Office Action Summary	Application No. 10/826,311	Applicant(s) STABEL ET AL.	
	Examiner Sara Addisu	Art Unit 3722

DETAILED ACTION

This Office Action is in response to the amendment filed 11/29/05. Currently, claims 1-22 are pending in this application.

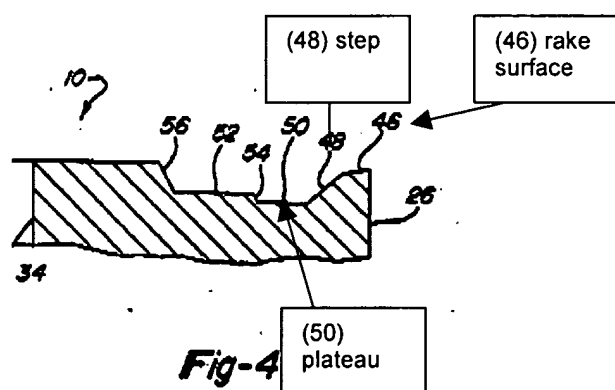
Katbi et al. teaches a cutting insert having a multi-cornered base body (square when viewed in top view, fig 2) including top and bottom surfaces (12 & 14), side flanks (26, 28, 30 & 32) interconnected by corner surfaces, cutting surface (36) on top and/or bottom surface, peripheral cutting edge (38) formed at the intersection of side flanks and top and bottom surfaces (12 & 14) (see figure 1 and Col. 2, lines 40-45). Katbi et al. also teaches the cutting surface having a central bore (34), a plateau (50 with raised support pads 52) located on the top and bottom surfaces surrounded by a peripheral positive rake surface (46) that is situated between the plateau surface and the cutting

edge (38) (see diagram below). Furthermore, Katbi et al. teaches an upwardly extending variable peripheral step (48) interconnecting the plateau (50) and the rake surface (46) (with the corner step portions extending uninterruptedly along the respective corner rake surface portions) (see figure 2, which also shows that step (48) is linear when viewed perpendicular to the cutting surface). Additionally, Katbi et al. teaches side flanks forming obtuse corners (see figure 2). Katbi et al. also teaches in figure 3, lateral cutting edge (38) having a sagging middle portion therefore the step is of varying height having a maximum height is disposed at the corner step portions and a minimum height midway between the adjacent corners (refer to the explanation and figure below regarding the varying height of the step: see argument under Response to Arguments). Regarding claim 19, Katbi et al. teaches variable width land surface (rake) which is changes width at (44) leading to a wavy step portion around the corners (see figure 2 and Col. 2, lines 49-54).

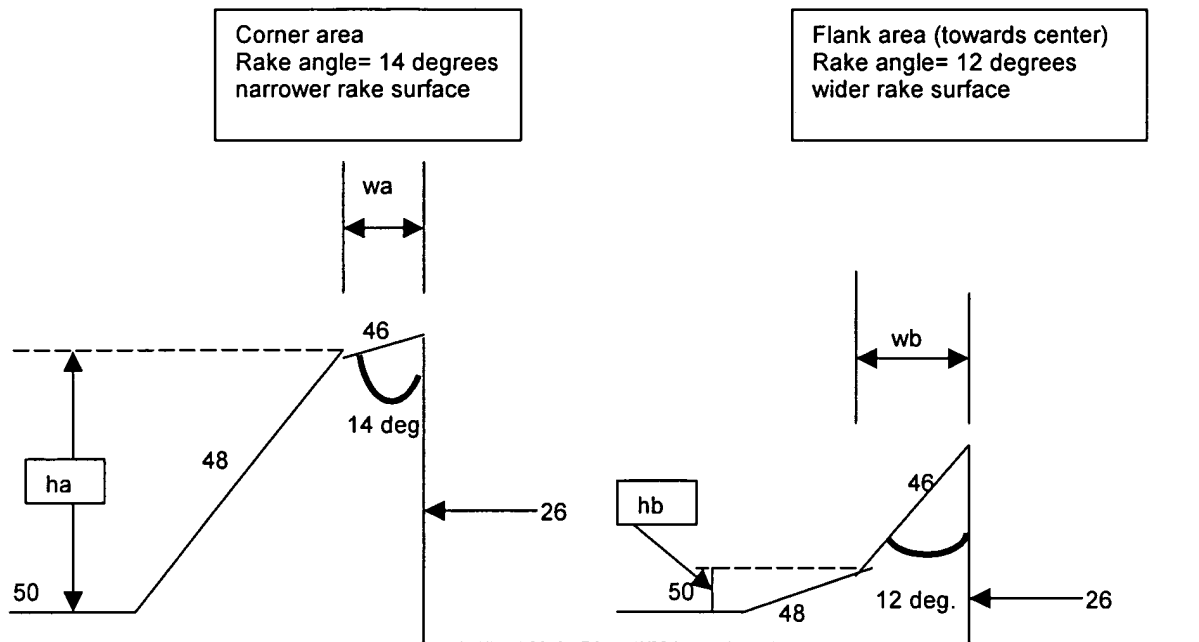
8. In response to Applicant's argument regarding claim 1 (page 8, lines 6-11) that *"As described at col. 2, lines 45-47, the cutting edge 38 is in the shape of a descending arc 40 from corner to each adjacent corner of the insert. However, irrespective of the arc shape of the cutting edge, as clearly illustrated in Fig. 1, the height of the step 48 is uniform all along the circumference of the cutting insert. There is no variation at all. The height of the step is the same at the corner of the cutting insert as well as at the middle between two corners"*, Examiner respectfully disagrees. Examiner points out that Katbi et al. teaches the cutting edge (38: which is arched) has a descending rake (46) located rearward from the cutting edge and the descending rake face is followed by a descending step (48) ('591, figure 4 and Col. 2, lines 45-58 and 66-68). If the height of the step was constant then the step would no longer be descending towards the center of the insert but rather ascending since the rake surface just forward of it has a variable descending angle. See figure below for further explanation (the angles are exaggerated). Katbi et al. teaches the rake face (46) having descending angle 14 degrees and narrower width (wa) at the corner and 12 degrees and a wider width (wb) towards the flank ('591,

Col. 2, lines 58-60 and 51-53). As shown below, the left figure indicates corner portion where the cutting edge is at it's highest height (because it's arched at the center), however the rake face has a wider descending angle and a narrower width (wa) which leads to the following portion (i.e. descending step, 48) to start descending from a higher location to plateau 50. On the other hand, the right hand figure represents the flank area such as the center where the cutting edge is at its lowest height (because it's arched at the center), however the rake face has a smaller descending angle and a wider width (wb) which leads to the following portion (i.e. descending step, 48) to start descending from a lower location to plateau 50, thus there is a height difference (ha is higher than hb) (i.e. the step has a varying height, wherein a maximum height is disposed at the corner step portions, as recited in claim 1).
